Planning Commission
Council Chambers
October 18, 2022 – 6:00 p.m.
233 South Main Street, Monroe, Ohio

CITY OF MONROE
Inter-Office Correspondence

DATE: October 18, 2022
RE: Information Packet for October 18, 2022 Planning Commission Meeting at 6:00 p.m.

I. Case No. 2022-10-13— Consideration of Site Plan Application for Ohana Car Wash

A
SITE LIGHTING PLAN - LAYOUT
SL-1.0
SCALE: 1/16" = 1'-0"

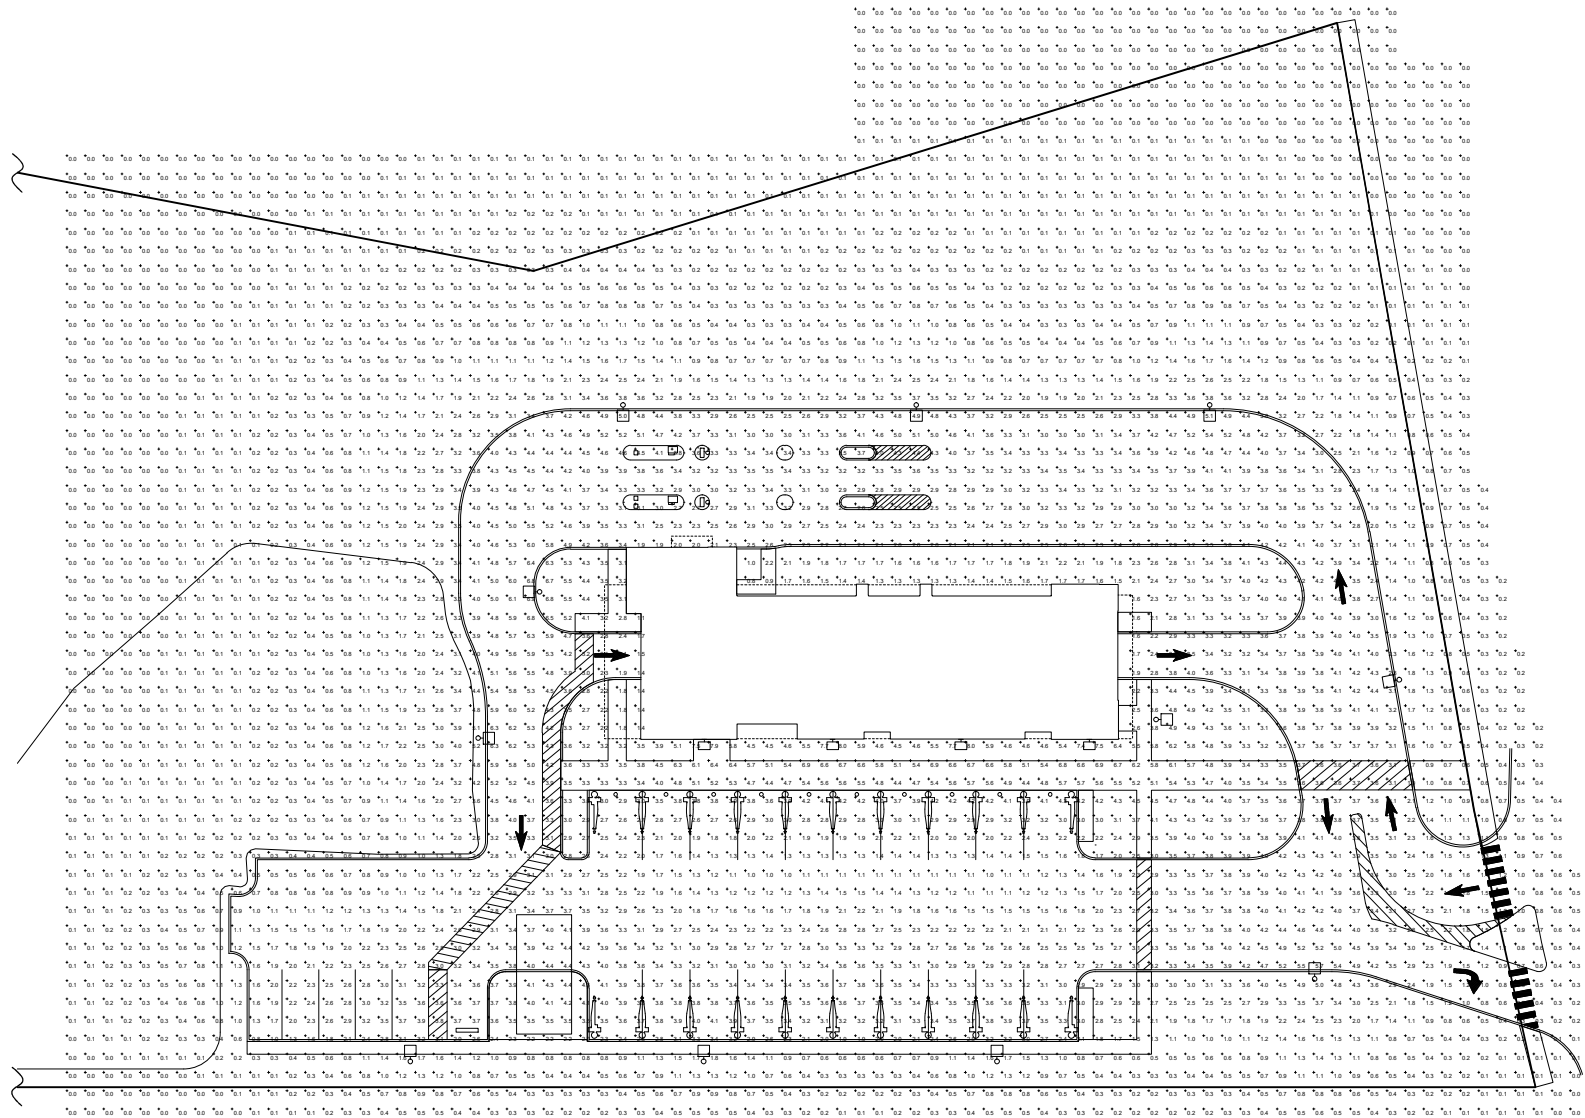
- Elevations along the south, west, and north sides meet this requirement.
- Photometrics:
 - Illumination is required consistently across the site shall be designed so as not to create dark spots that may create safety issues in such areas as vehicular use areas and connecting pedestrian paths.
 - Staff notes that all wall packs and any light fixture facing a residential district must be a cut-off type fixture so as to minimize light pollution.
 - The provided photometric plan appears to use an outdated site plan. Please revise.
 - The site appears to be underlit at the entrance at Baker Drive and along the sidewalk along the building on the south side. Please revise.
 - The site appears to be over lit in select areas along the southern property line. Please revise.

- The applicant will revise the lighting plan to address staff report comments.
